## Determination 2016/059

# Regarding the compliance of uPVC window and door joinery installed to a house at 9A Wellington Road, Feilding

**Figure 1: Changes in window details**

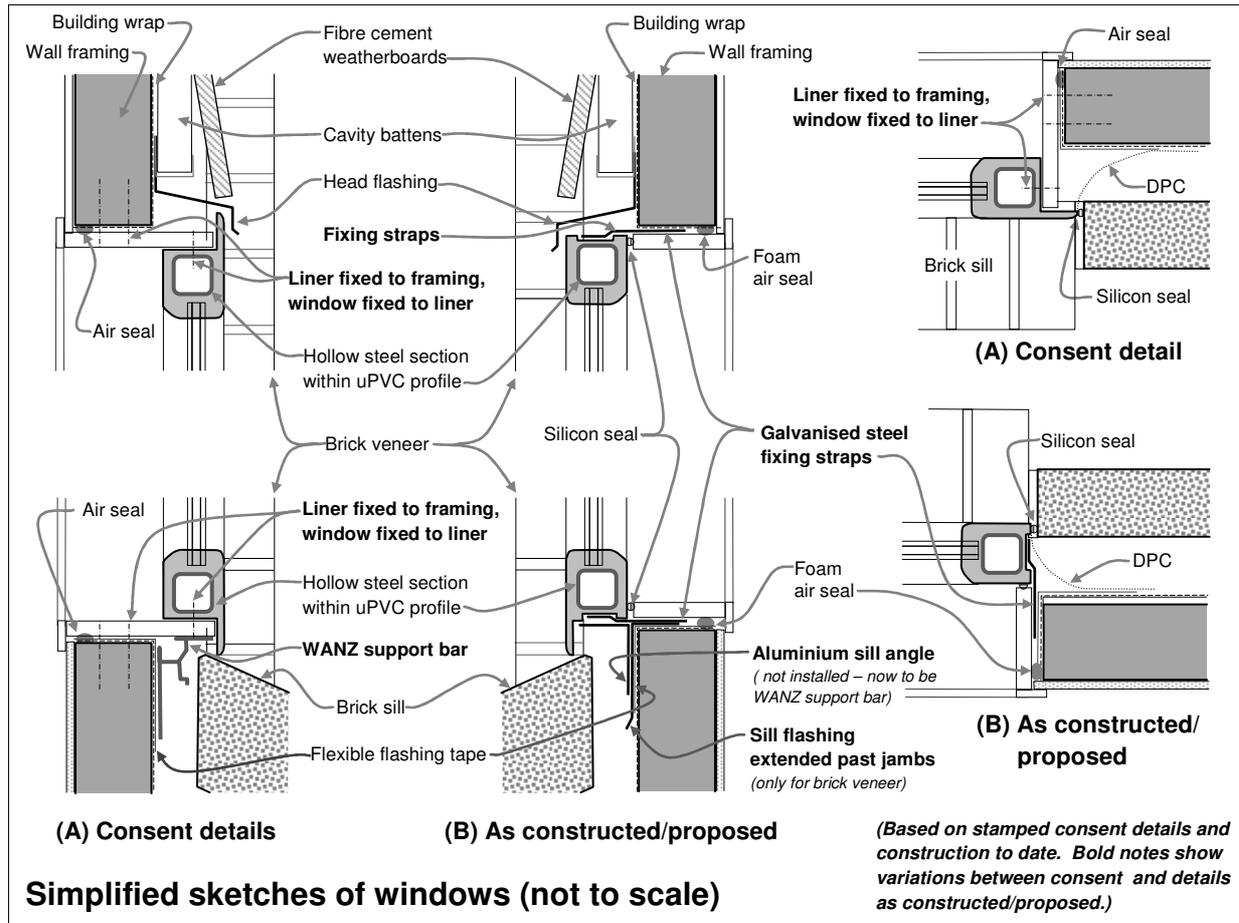
2.2.3 As shown in Figure 1, significant changes include the following:

(A) The consent joinery (consent drawing 21/03/16)	(B) The substitute joinery	
		Amendment details	As constructed/intended
<b>Profile</b>	uPVC extrusions with hollow steel sections within Full perimeter flange	uPVC extrusions with hollow steel sections within Flange at sill only	
<b>Fixing</b>	Timber reveal fixed to timber framing and into profile RHS	Galvanised fixing straps shown, with no size, spacing or fixings. Reveals cut to suit following window installation, with silicon bead at junction with profile	0.55 x 25mm standard galvanised steel strip brace at about 400mm centres, fixed to framing with single screws Reveals not yet installed
<b>Support</b>	WANZ <sup>5</sup> sill support bar shown	50mm aluminium support angles noted – but not shown or identified in sill detail. WANZ sill support bar not shown	Aluminium support angles not yet installed Owner/supplier now intends to use WANZ sill support

<b>Flashing</b>	No sill flashing shown	Sill flashing with kickout shown for brick veneer cavity only

- 5.2.1 The expert noted the following changes in window installation between the details supplied for the proposed consent amendment and the consent details (see Figure 1):
- the weatherproofing of the installation details are not significantly different
  - the size, spacing and fixings of the fixing straps are not provided

- the size, thickness and fixings of the aluminium support angle are not provided.

- the detailing shown in the consent application and the weathertightness of joinery installation completed to date appeared to be adequate.
- 5.5.4 Taking account of the verifiable testing carried out and certification obtained to date, the expert also noted that other paths might be taken to demonstrate compliance, including (in summary):
